# **ADDENDUM**

November 22, 2017

**RFB NO. 316048 (REBID) - ADDENDUM NO. 1**

**NEW RESTROOM FACILITY - HENRY VILAS ZOO**

**A700**

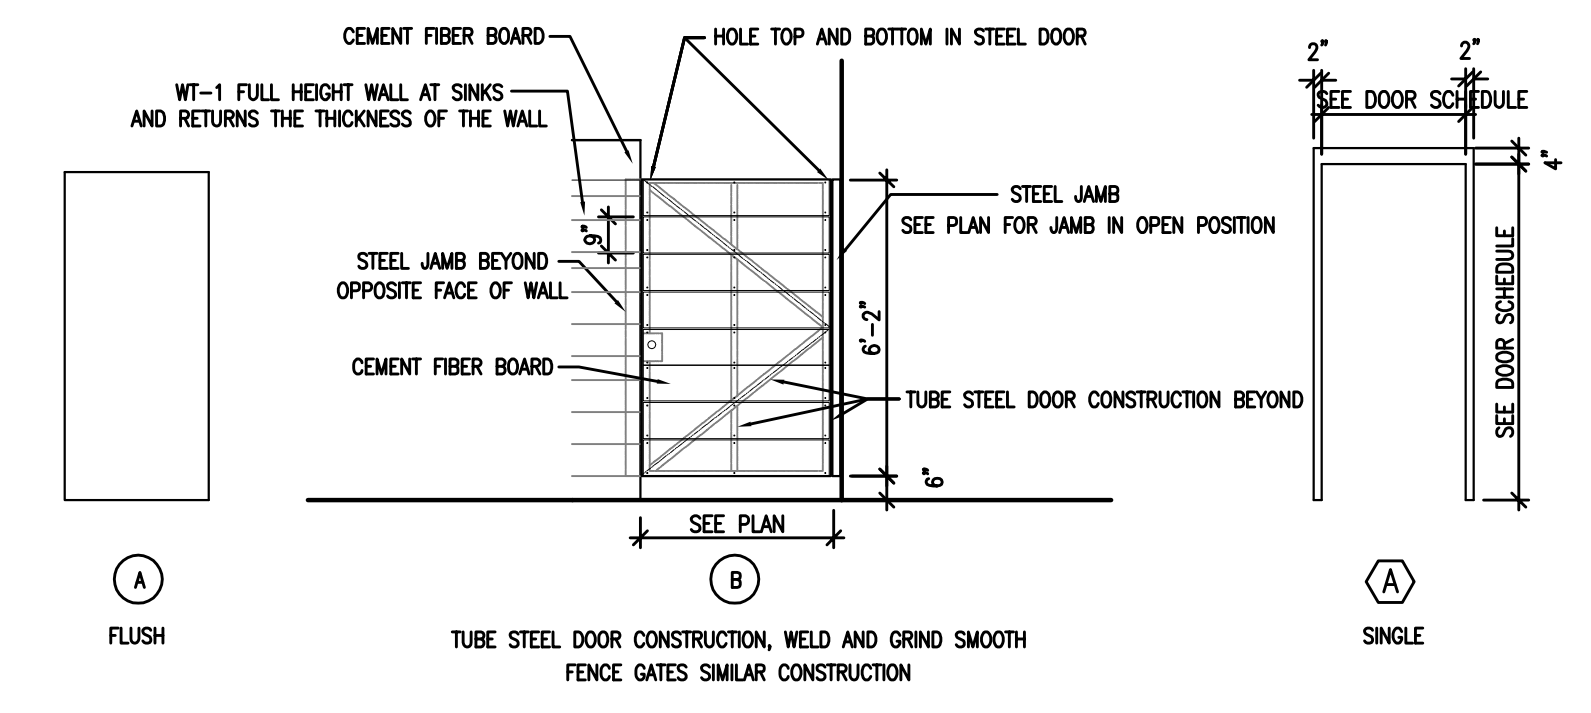
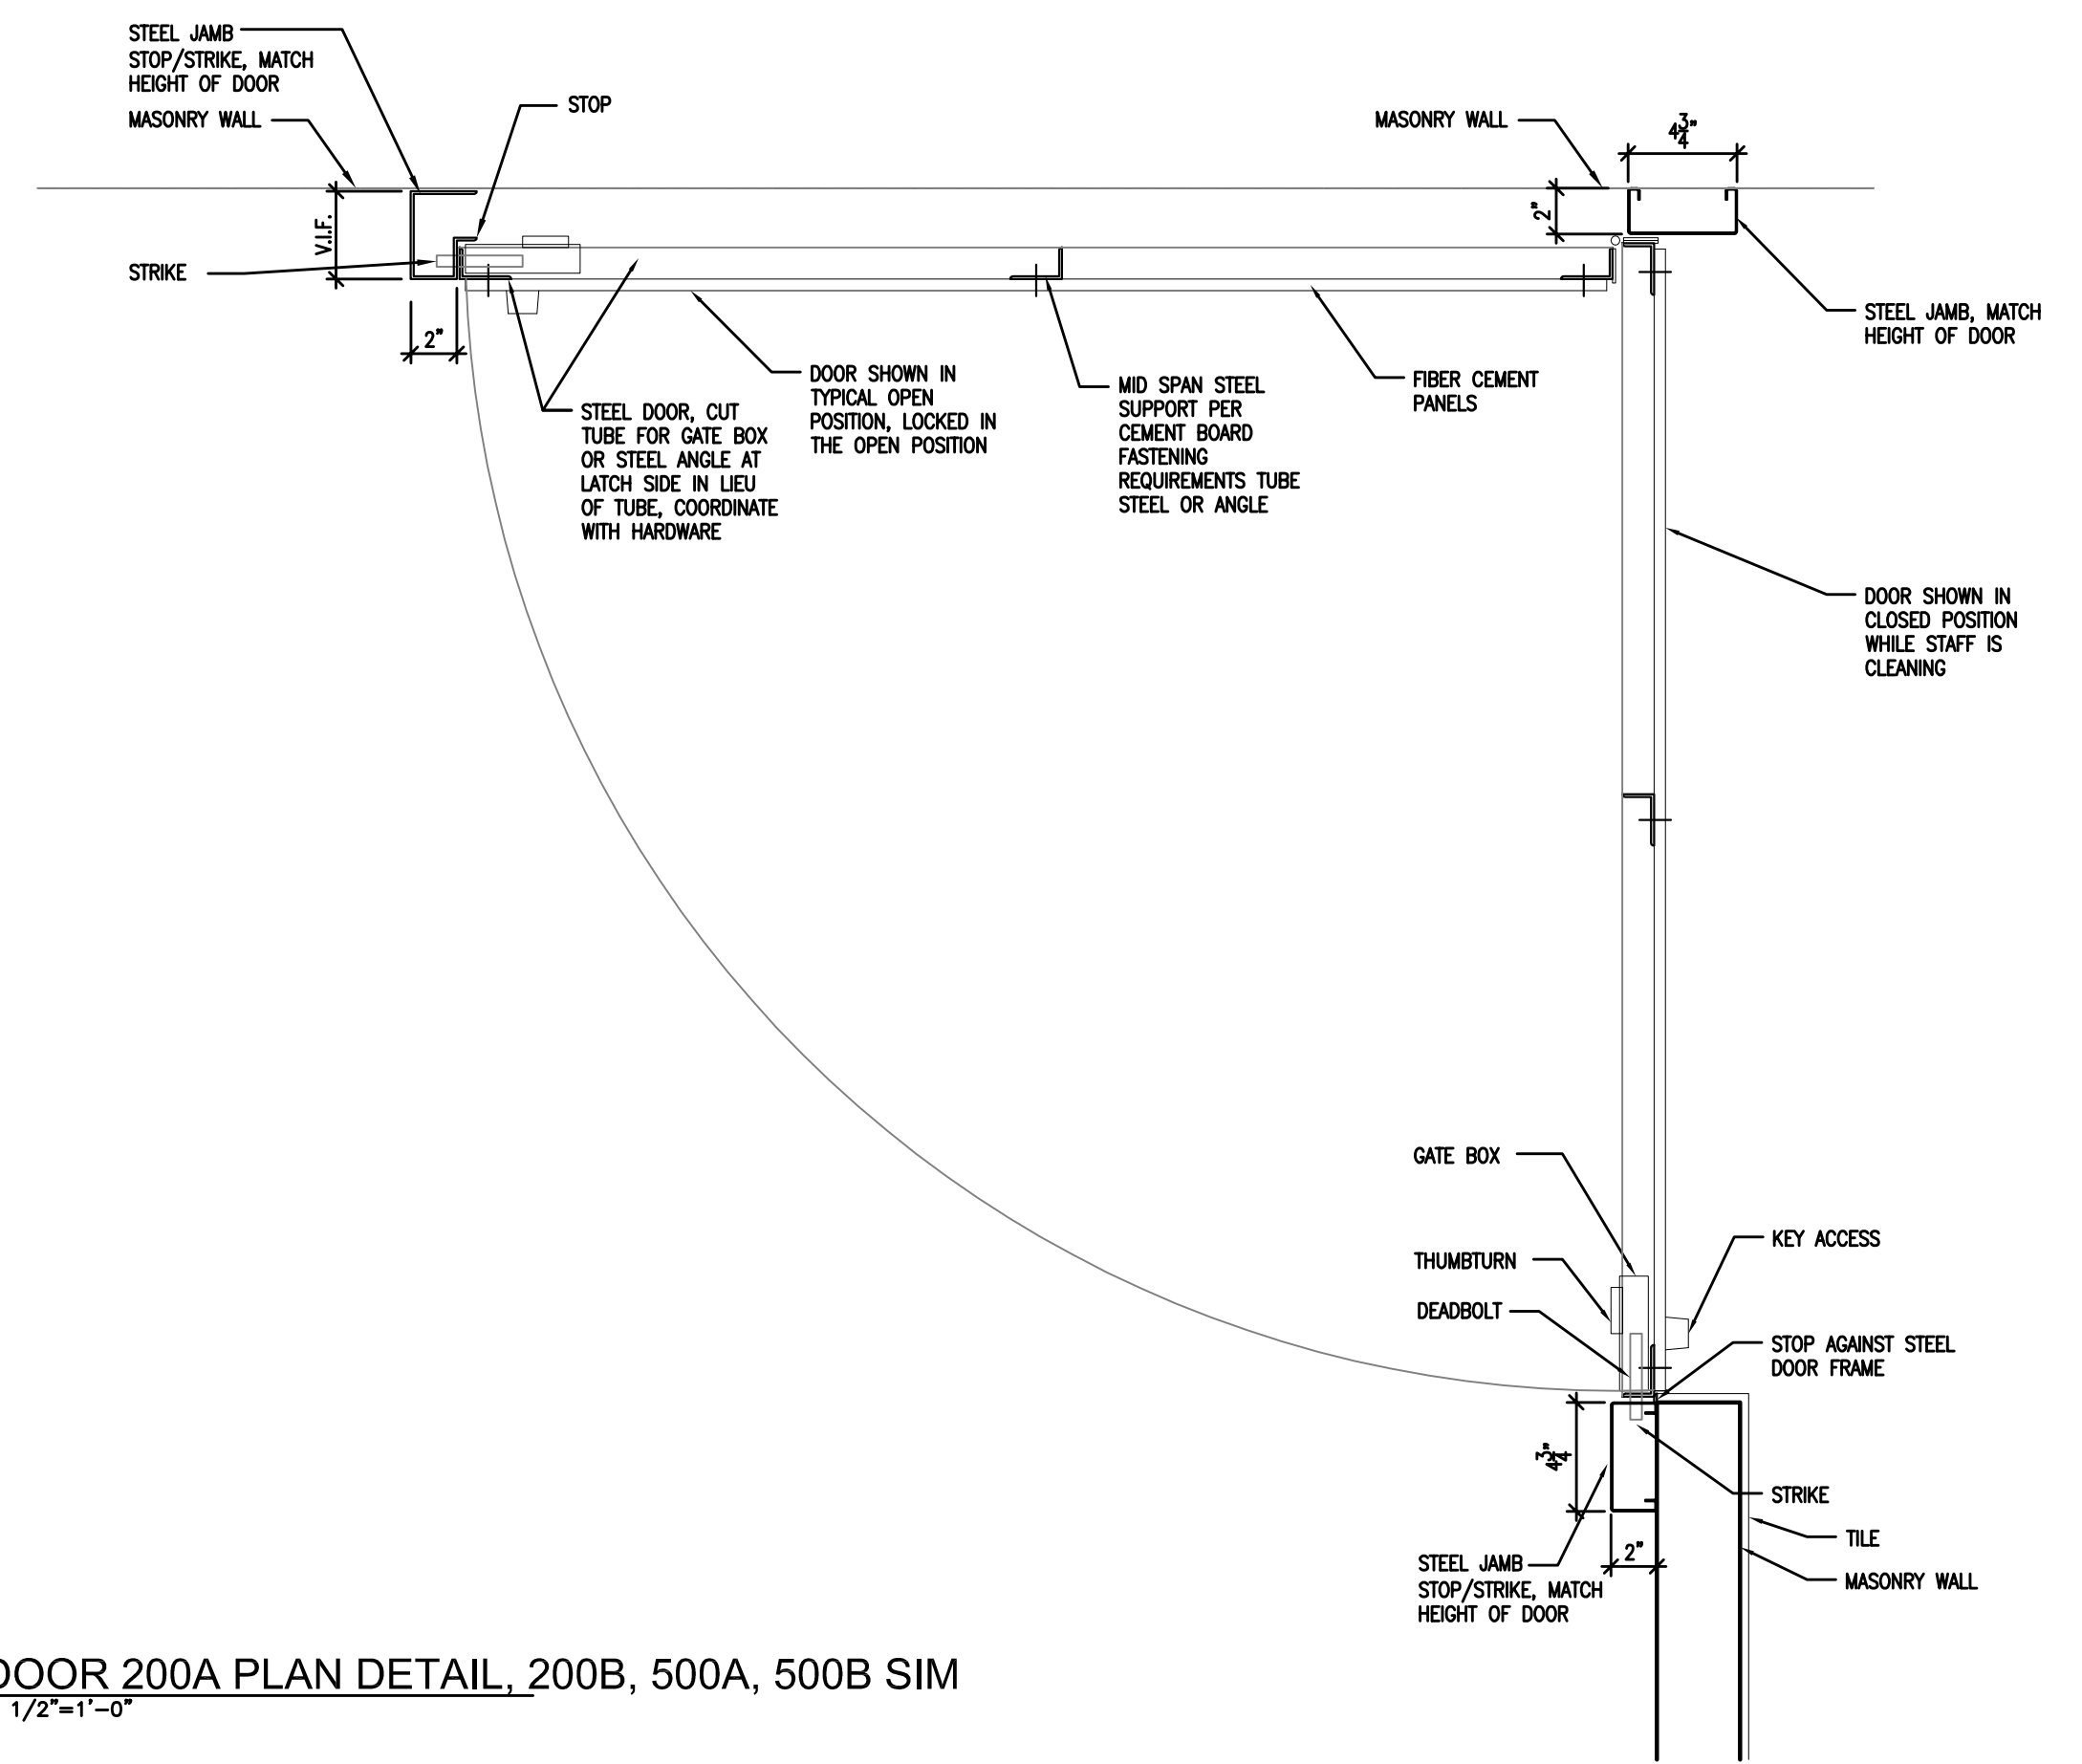
- 7. A700 Details
  - a. Add sheet A700 and replace Door and Frame Schedule in section 08 71 00 with the schedule on A700.
- 8. S100 Foundation Plan and General Structural Notes

- c. Revise Set 05 to:
    - 3 EA SPRING HINGES LB4390-350 630 BOM coord w/ steel door/frame dimension
    - 1 EA DEADBOLT MBT-3-S 626 MARSHALL BEST
    - 1 EA GATEBOX COORD W/ HARDWARE KEEDEX
    - Paint Gate Box to match steel door/frame
  - d. Omit Door and Frame Schedule in 08 71 00. Refer to attached sheet A700.
3. 23 07 00, Page 9, Duct Insulation Schedule: Revise “Concealed Supply Ducts (Downstream of Duct Furnace and All Furnaces)” to say “Supply Ducts (Downstream of Duct Furnace and All Furnaces)”.

**E000**

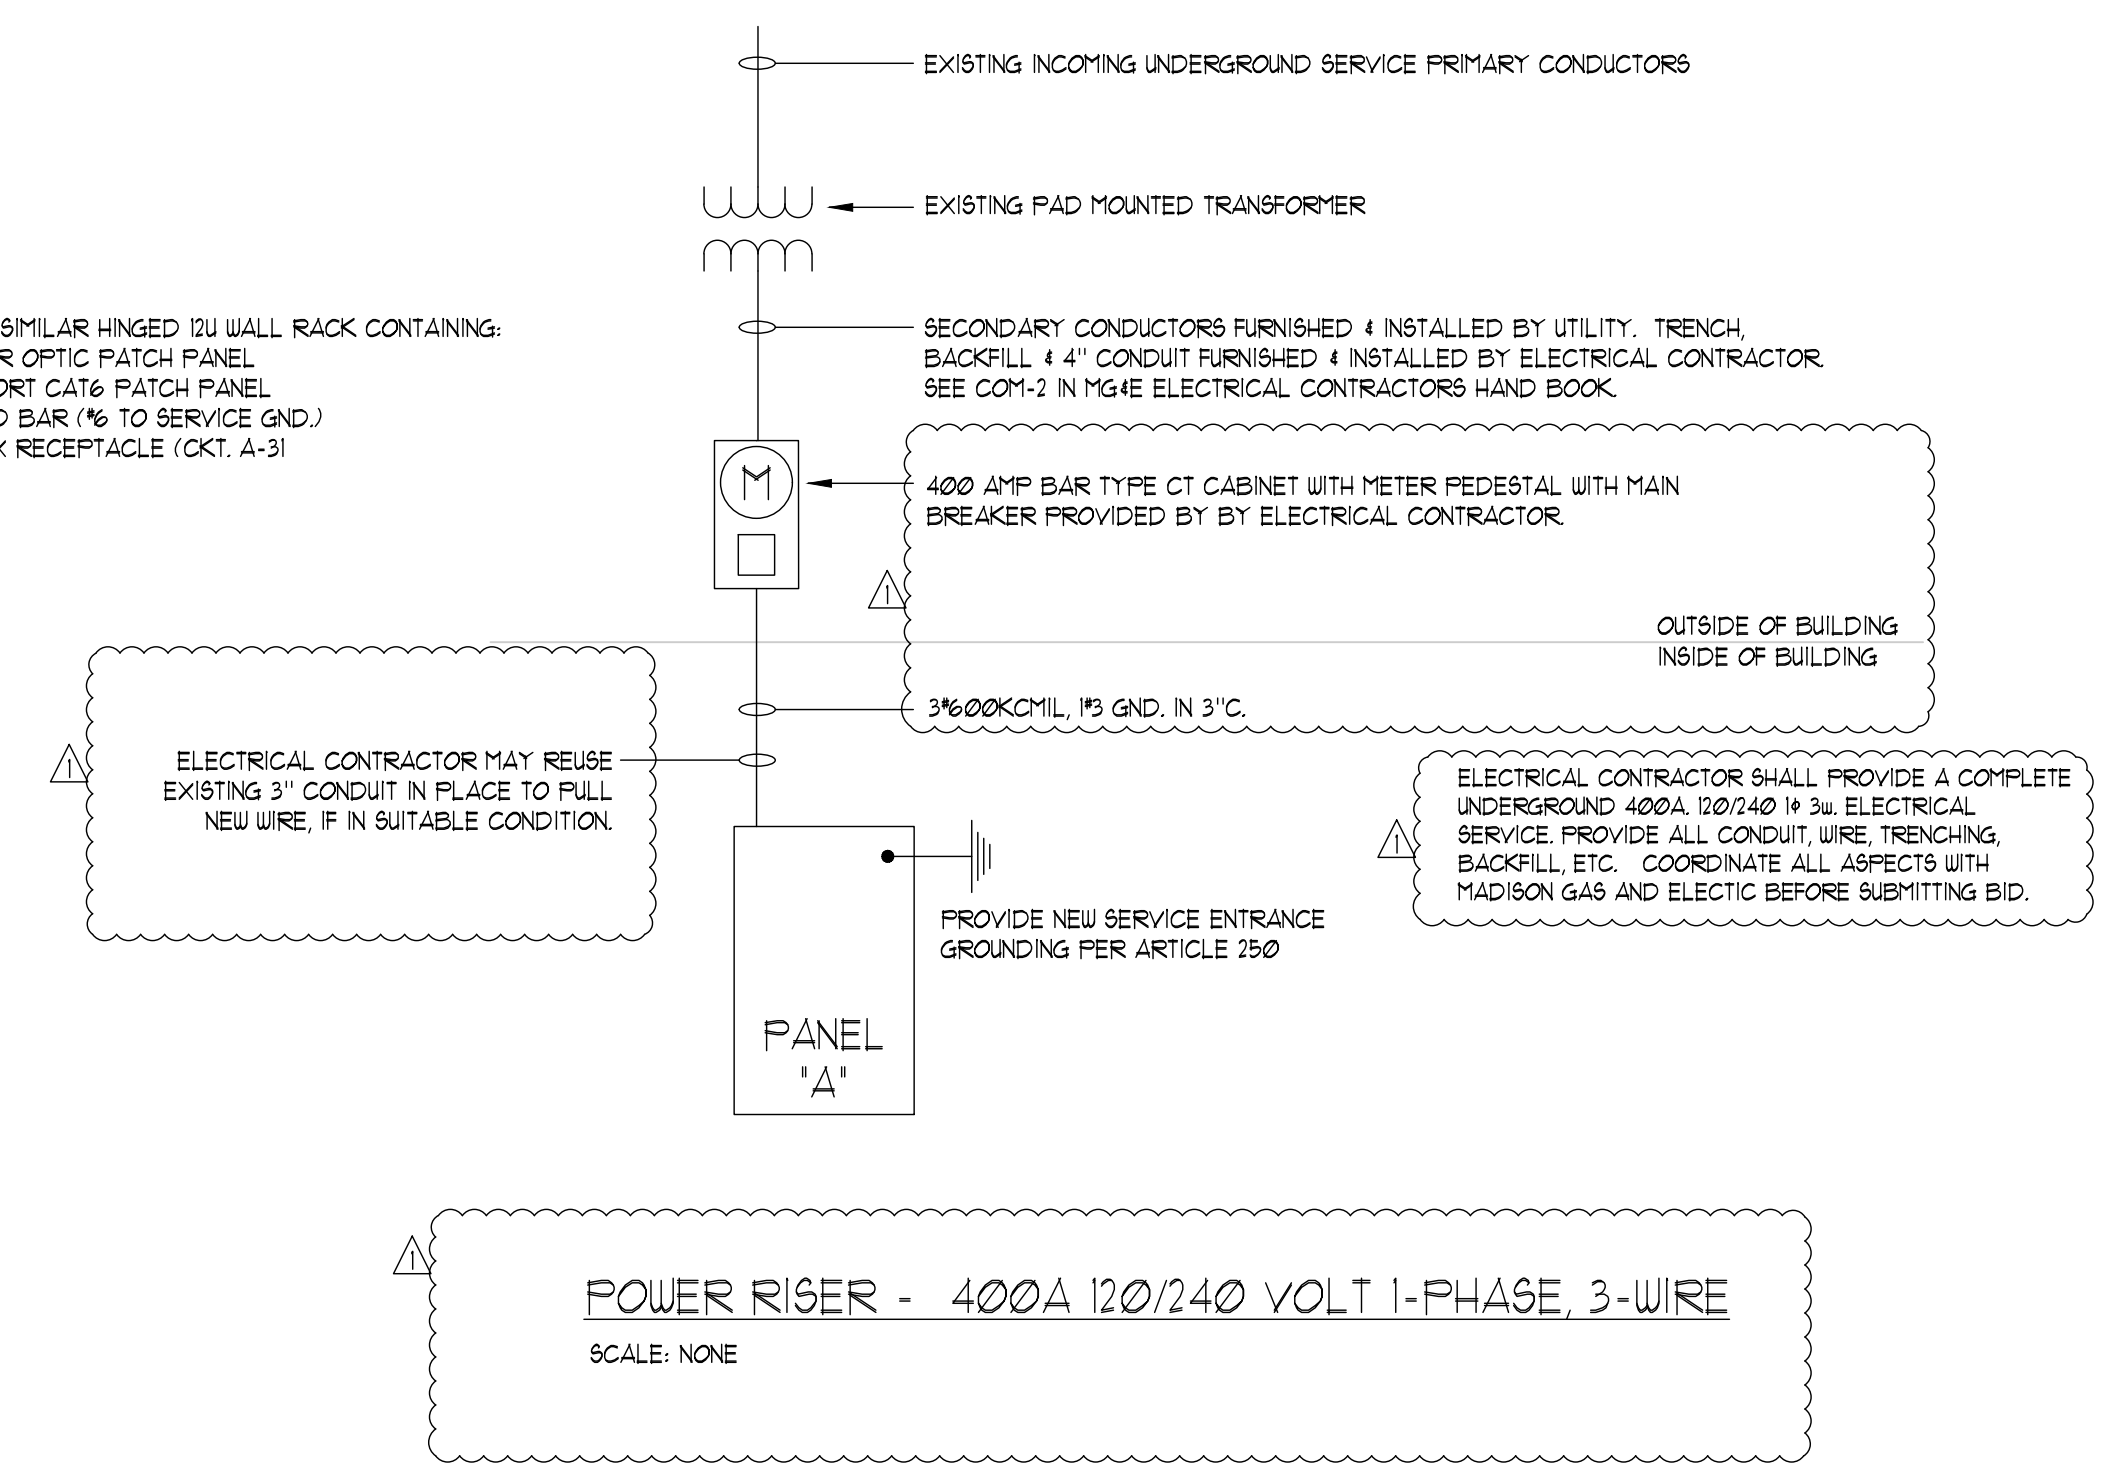
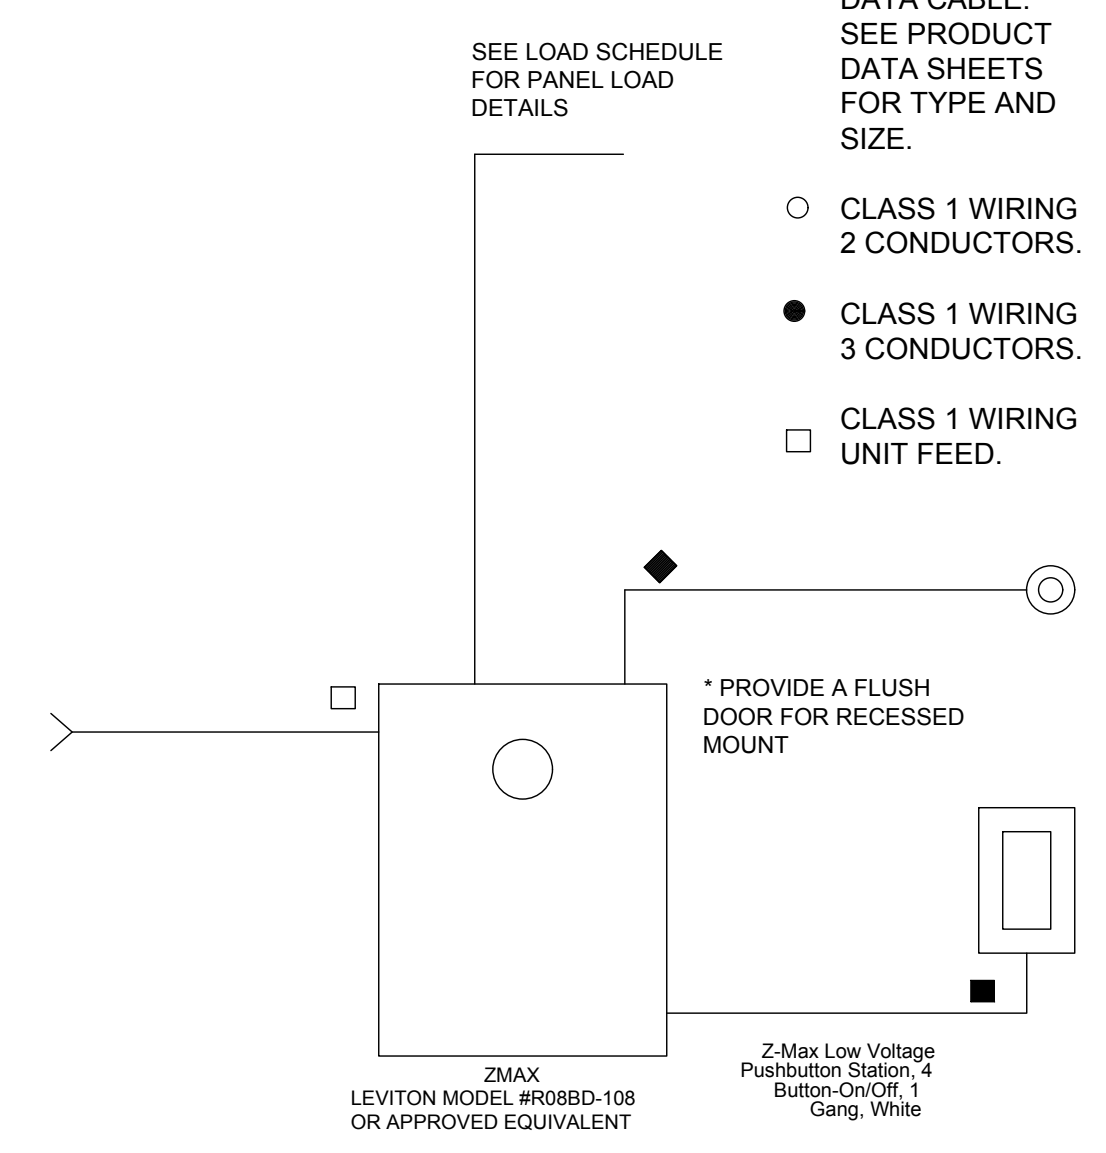
- a. Add the following Plan Note “Refer to architectural for CMU wall locations.”
- 9. E000 - Symbols, Abbreviations, Riser Diagram & Sheet Index, Revised drawing attached.

- a. Changed service on riser to 400 amps resized wire and conduit to fit new 400 amp service
  - b. Added note about reusing existing conduit.
- 10. E010 - Site plan Electrical
